DN-171.1  
EN-62.1  
FN-50.1

# SERVICE BULLETIN

**SUBJECT:** ONE-TIME INSPECTION OF 369D25623 OIL COOLER BLOWER BELT

Figure 1. Inspection of Oil Cooler Blower Belt.

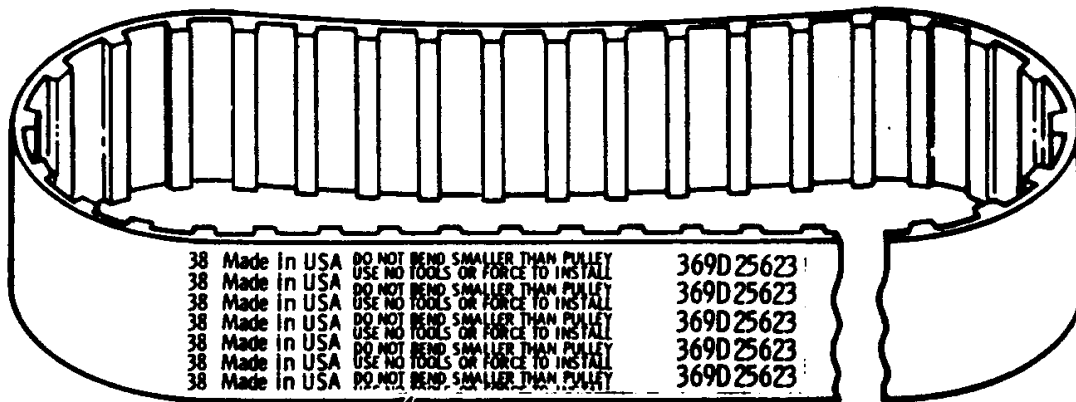
- a. Gain access to the oil cooling blower assembly.
- b. Inspect oil cooler blower belt as follows:
  1. Acceptable blower belts are identified by white PN 369D25623 followed by a three-digit code (see sample shown in Figure 1) with 3/16 to 1/4 inch high lettering along with some other numbering. In order to be acceptable the three digit code must be present.
  2. Blower belts identified with green part numbers and letters (refer to Figure 1) or belts without three-digit codes immediately after the part number must be replaced with acceptable belts per instructions contained in the appropriate Maintenance Manuals.
  3. Remove unacceptable blower belts from Spares Inventories. Return unacceptable belts to MDHC Warranty and Repair Department for warranty consideration/replacement.

THREE-DIGIT MANUFACTURER'S CODE MUST BE PRESENT  
WHITE MARKINGS ACCEPTABLE

GREEN MARKINGS UNACCEPTABLE
